Final Drainage Report - Amendment No. 1

Widefield Parks and Recreation Facility Expansion El Paso County, Colorado

PCD File Number: PPR-2213

Table 506-2

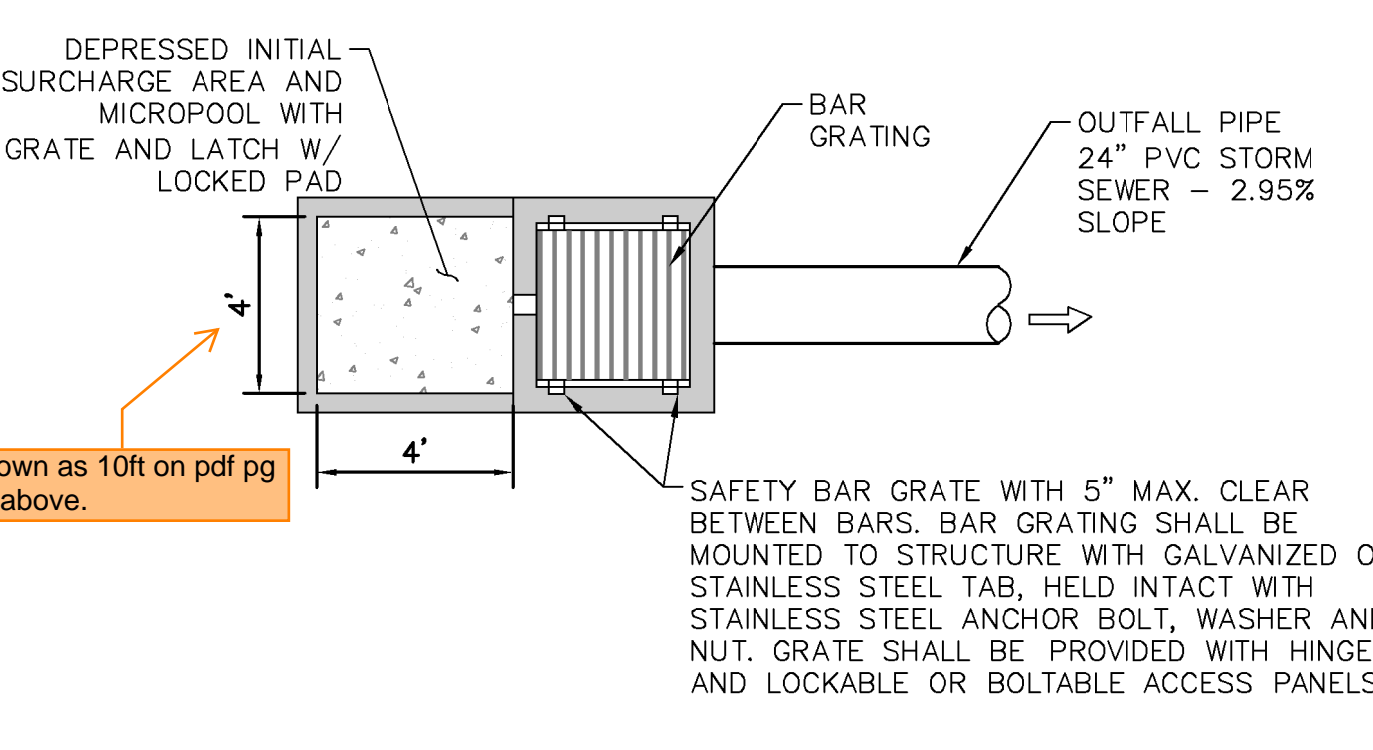
Also re-do UD-BMP spreadsheet to include the change in Effective Imperviousness and to the WQCV. This may subsequently effect the sizing of the forebay, which would need to be reflected with revisions on this detail.
